CHANGE REQUEST

⌘ **23.012 CR 015** ⌘ rev **4** ⌘ Current version: **5.2.0** ⌘

Title:	⌘ Addition of ADD feature		
Source:	⌘ Ericsson L.M., Siemens, Telefonica, T-mobile		
Work item code:	⌘ TEI6	Date:	⌘ 11/03/2004
Category:	⌘ B	Release:	⌘ Rel-6
	<i>Use one of the following categories:</i> F (correction) A (corresponds to a correction in an earlier release) B (addition of feature), C (functional modification of feature) D (editorial modification) Detailed explanations of the above categories can be found in 3GPP TR 21.900 .		<i>Use one of the following releases:</i> 2 (GSM Phase 2) R96 (Release 1996) R97 (Release 1997) R98 (Release 1998) R99 (Release 1999) Rel-4 (Release 4) Rel-5 (Release 5) Rel-6 (Release 6)

Figure 4.1.2.1 (sheet 1 of 3): Process Update_Location_Area_VLR

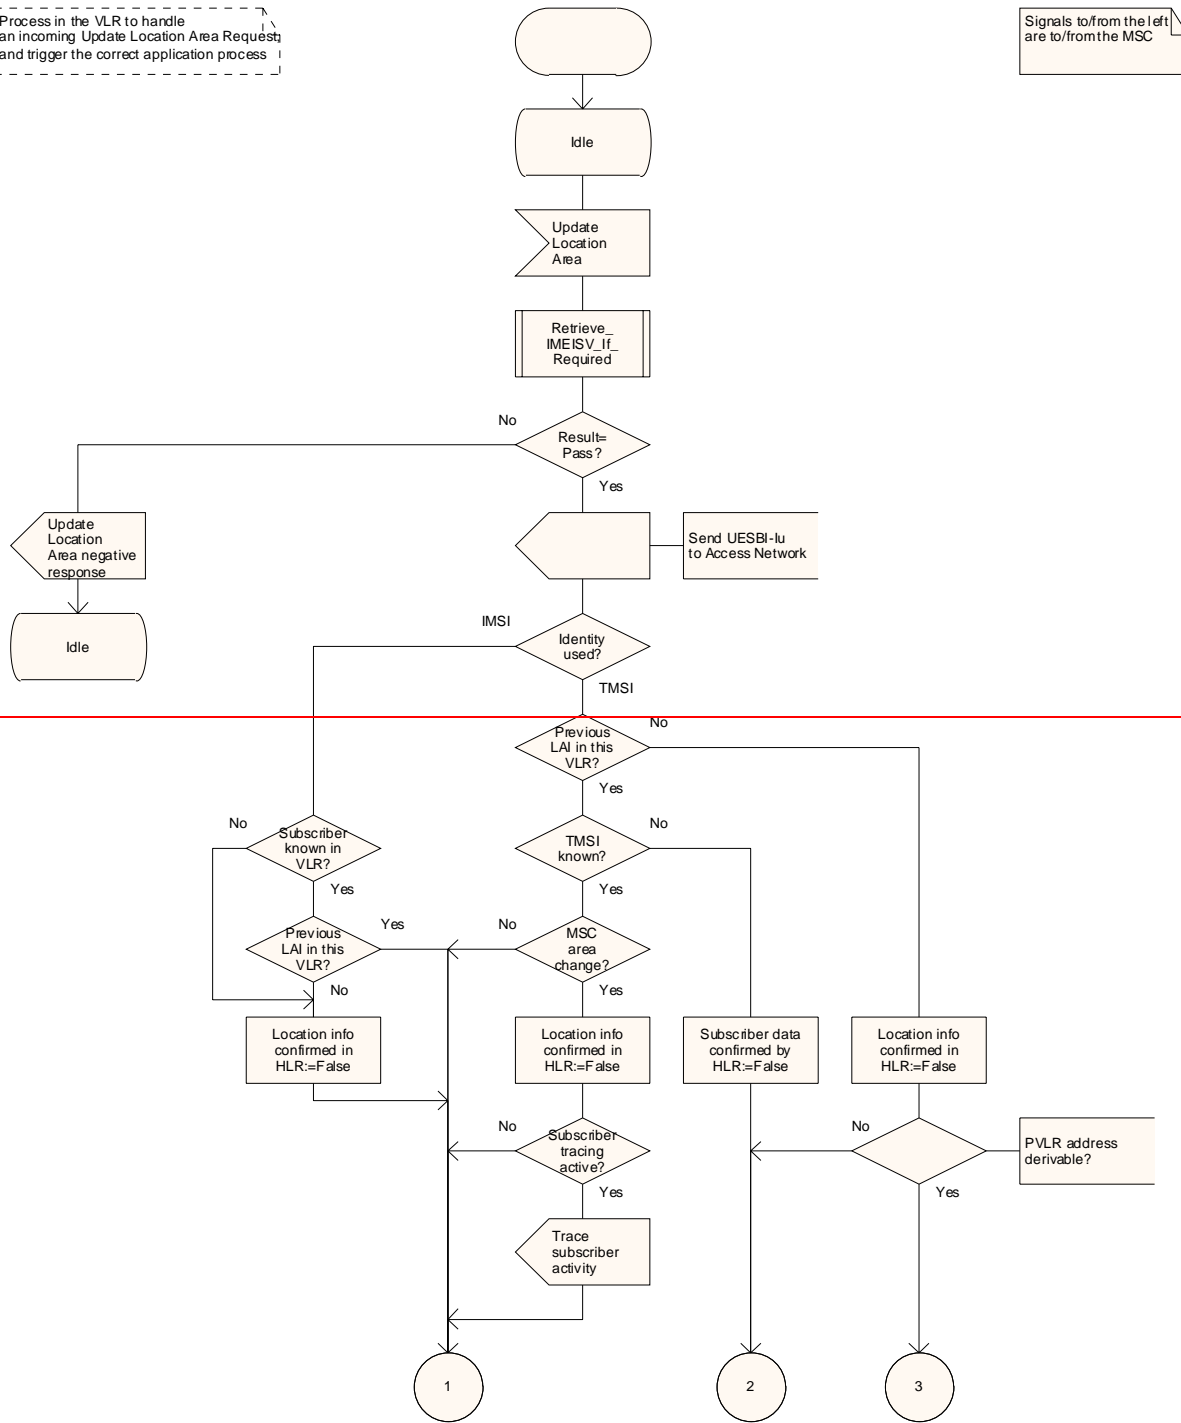
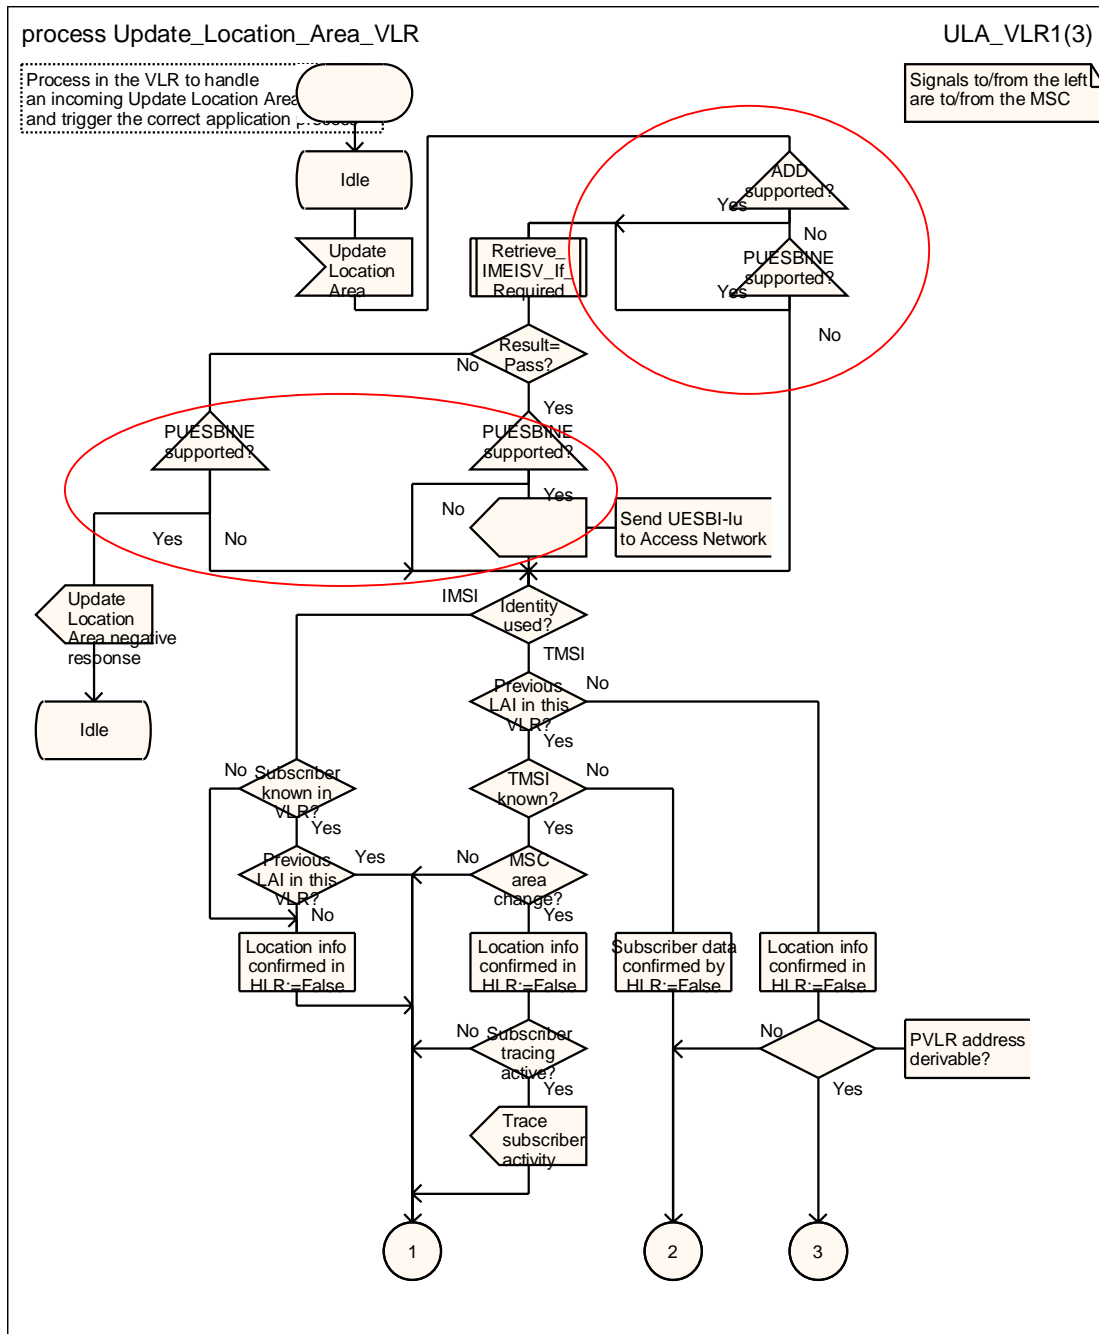
~~Sheet 1: the handling starting with the procedure call "Retrieve_IMEISV_If_required" and finishing with the output signal "Send_UESBI-Iu to Access Network" is specific to PUESBINE. If the VLR does not support PUESBINE, processing continues with the test "Identity used?".~~

The ADD function is an optional feature that allows the HLR to be updated with the current User Equipment (IMEISV) and thus enables the network to configure the subscriber's equipment based on a predefined profile. A device management system can retrieve the IMEISV either from VLR or from HLR, or be triggered by a changed IMEISV in either VLR or HLR. The mechanism for the configuration is outside the scope of this specification. The VLR requests the IMEISV and checks if the stored value is identical to the current one provided at the IMSI Attach/Location Update. If the IMEISV is not the same an Update Location message on MAP to the HLR is triggered including the IMEISV.

Figure 4.1.2.1 (sheet 2 of 3): Process Update_Location_Area_VLR

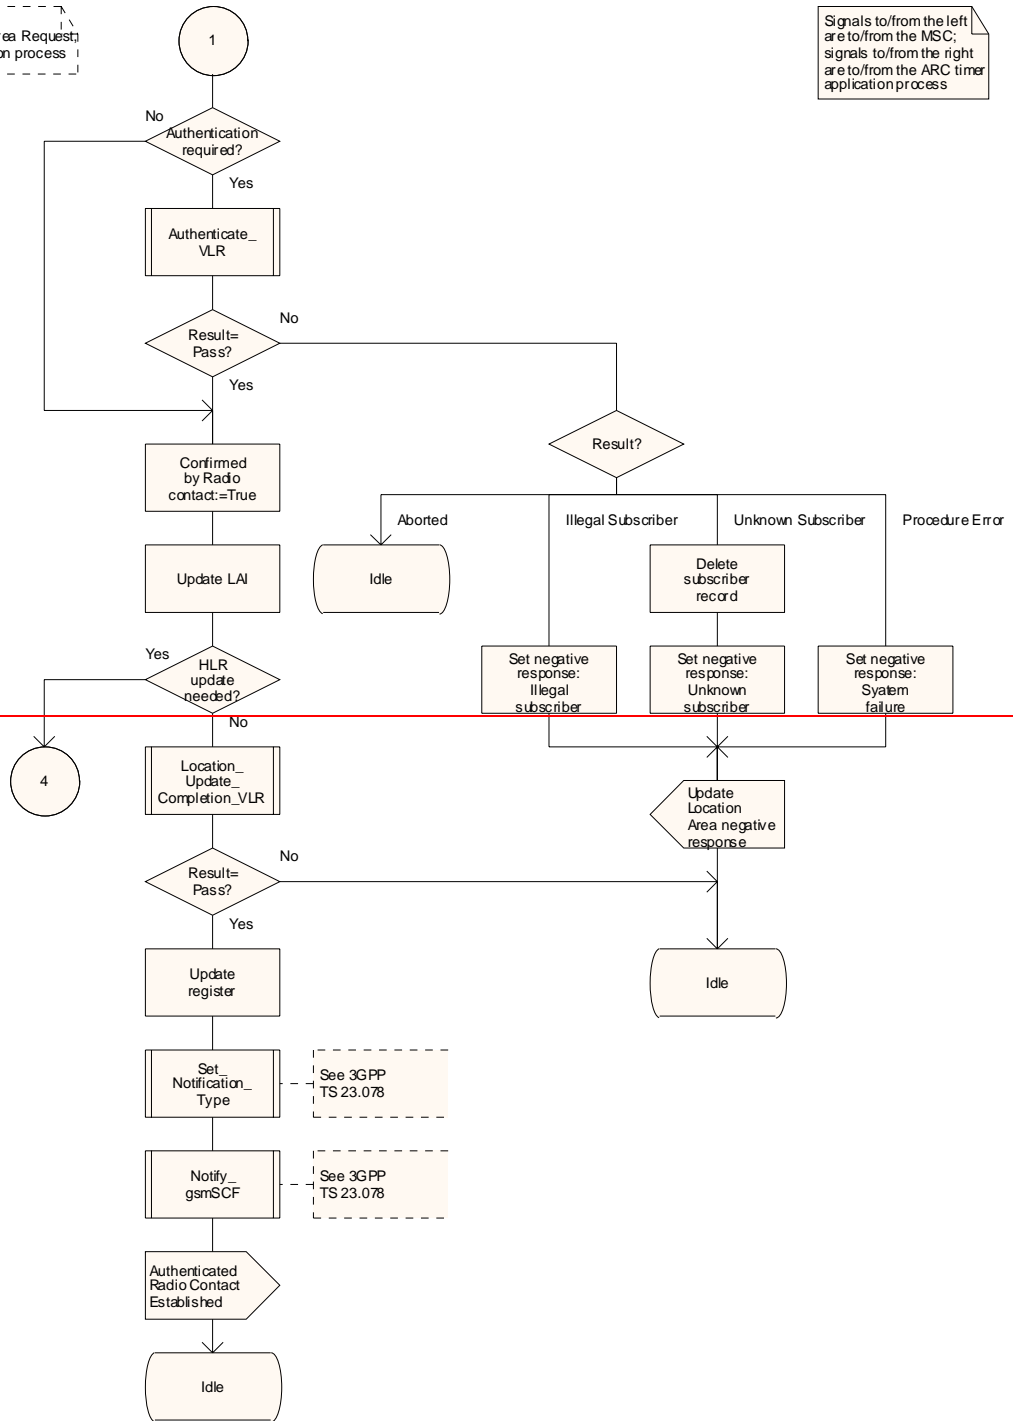
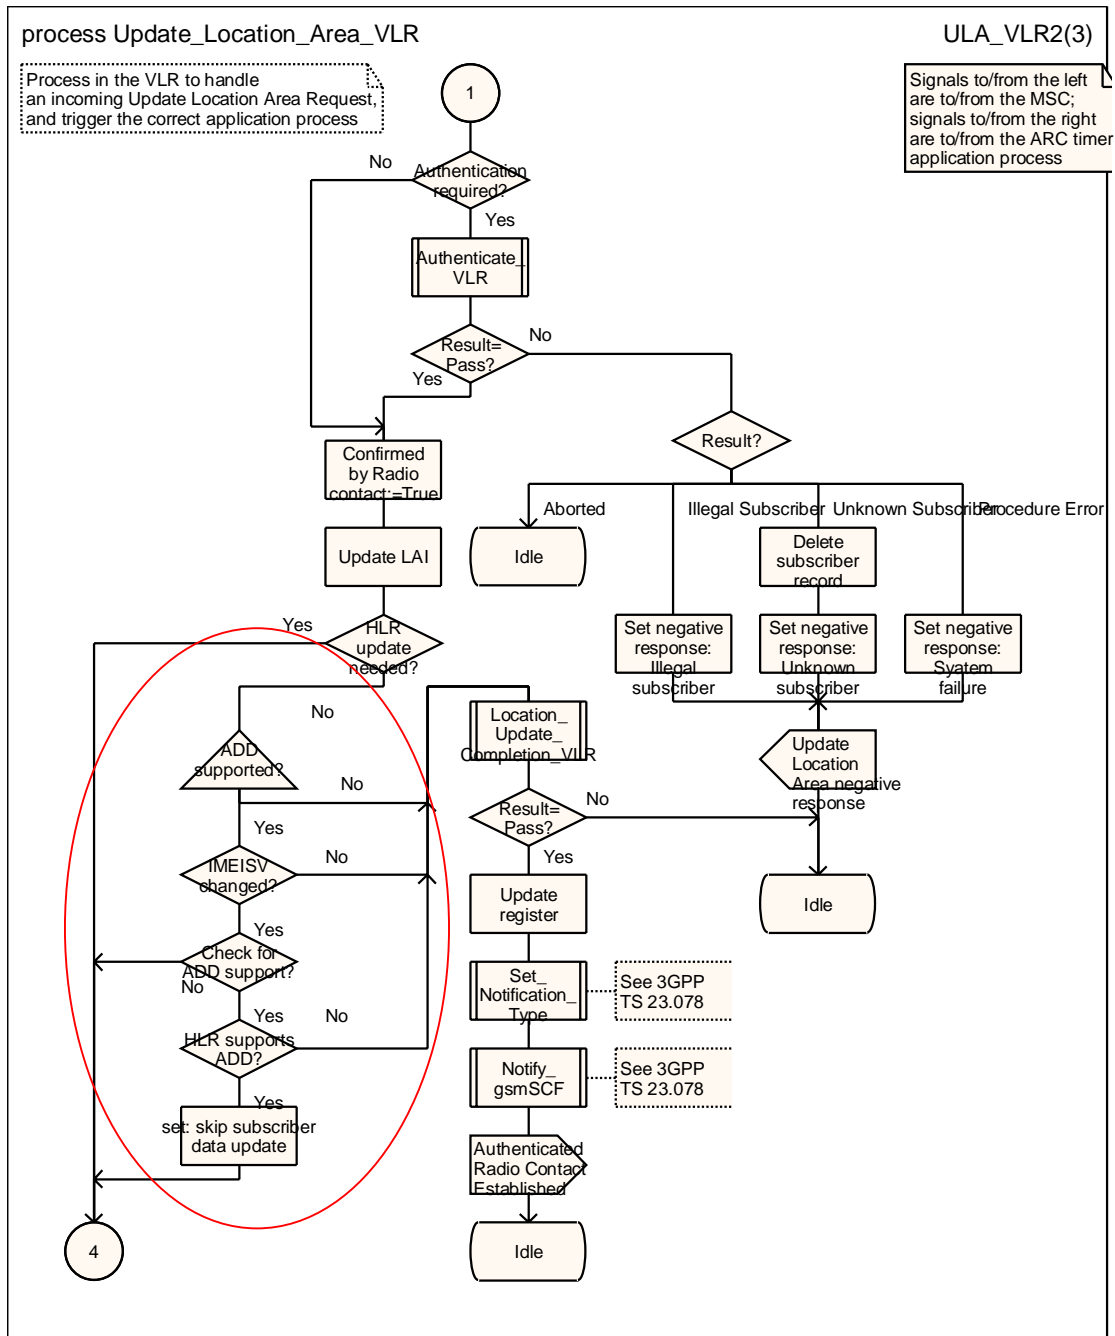
Sheet 2: : The execution of the test "HLR supports ADD?" and the action "set: skip subscriber data update" is an operator configurable option.

Figure 4.1.2.1A: Procedure Retrieve_IMEISV_If_Required

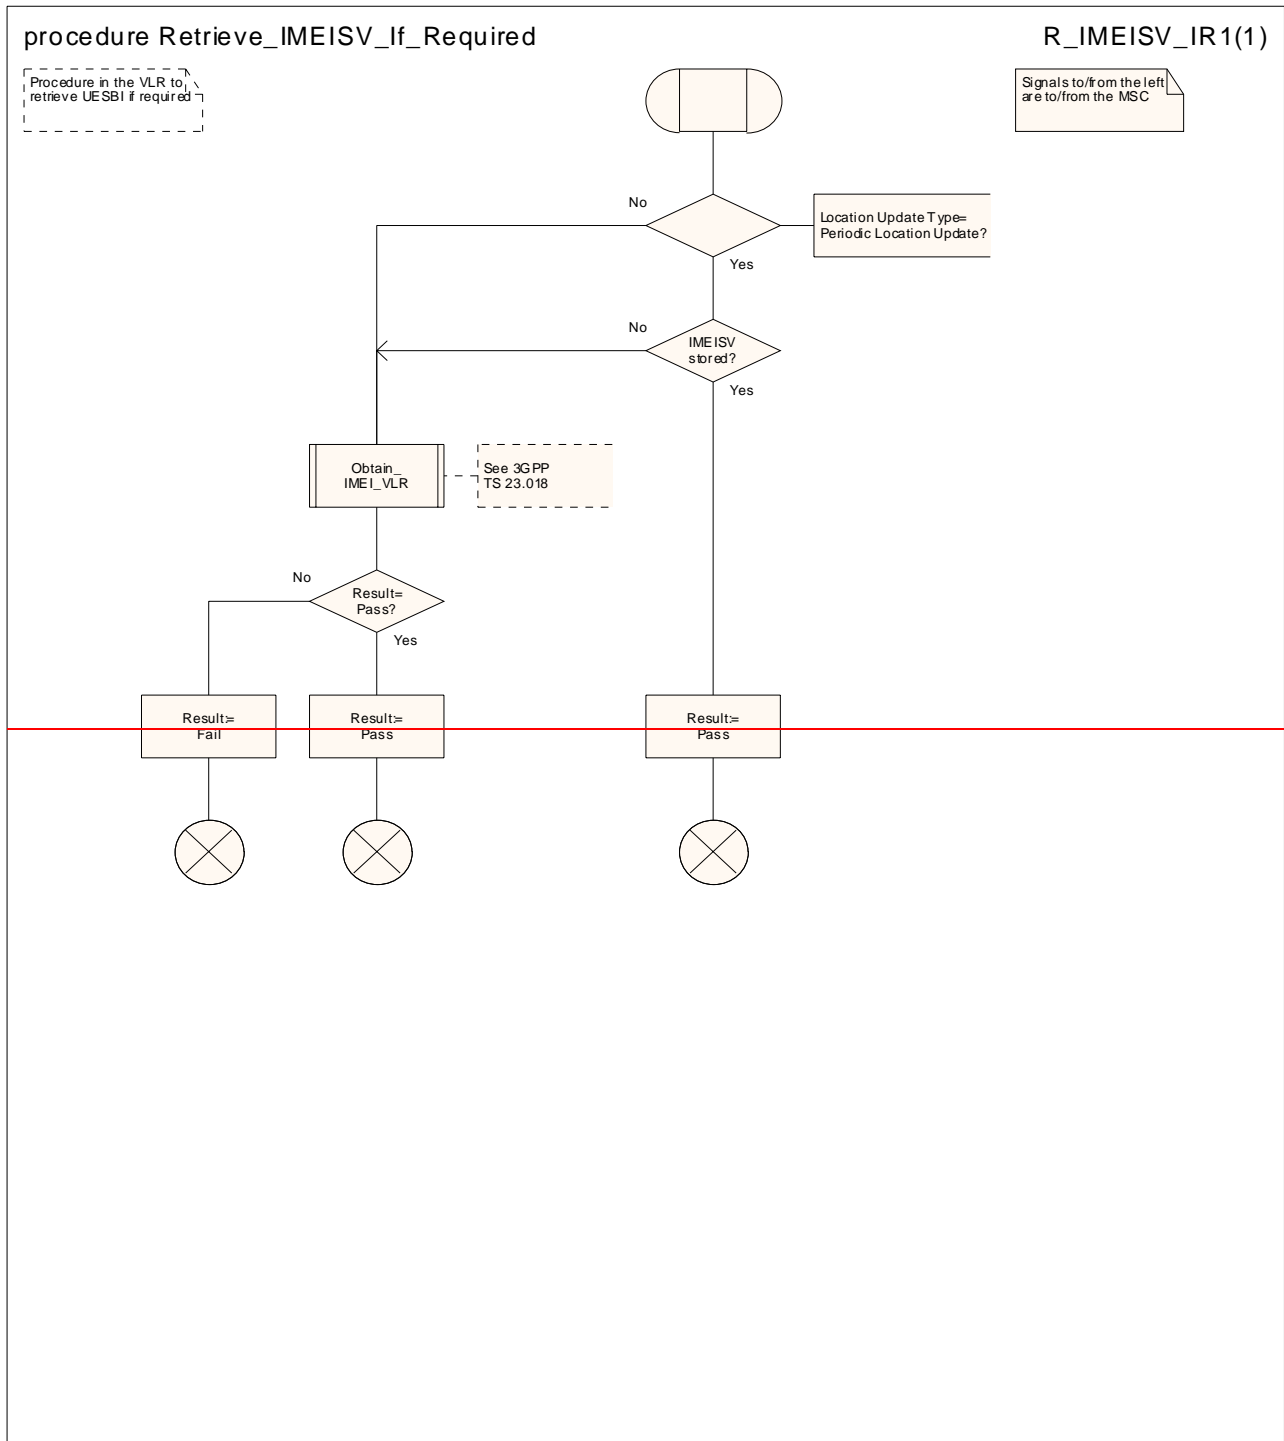
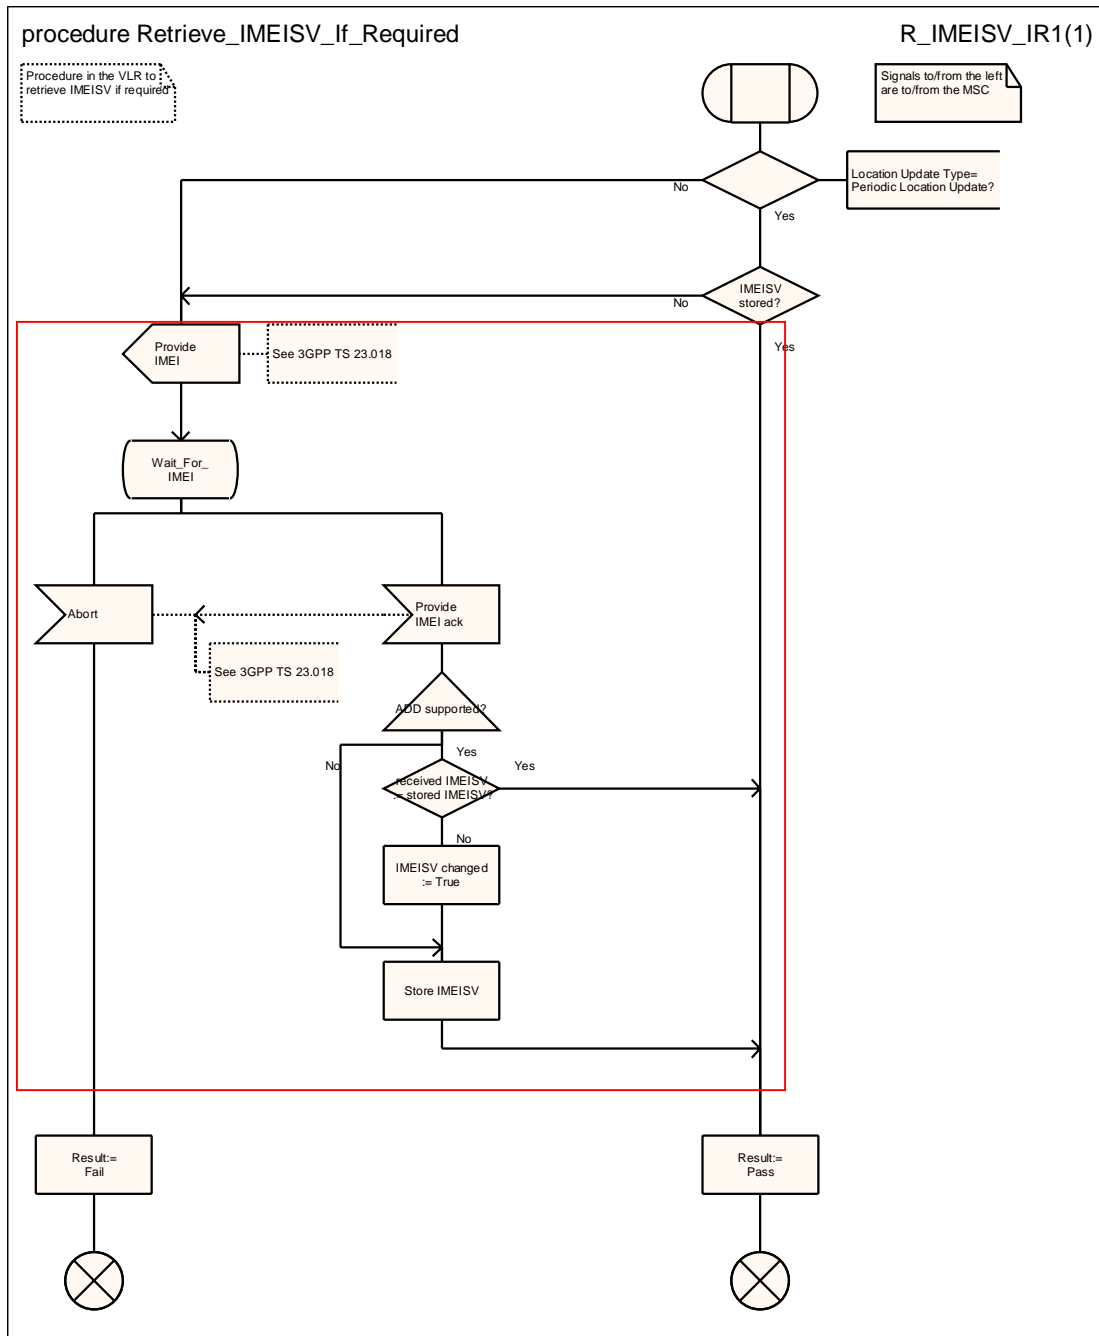
The decision box "received IMEISV = stored IMEISV" takes the "No" exit if no IMEISV is stored.
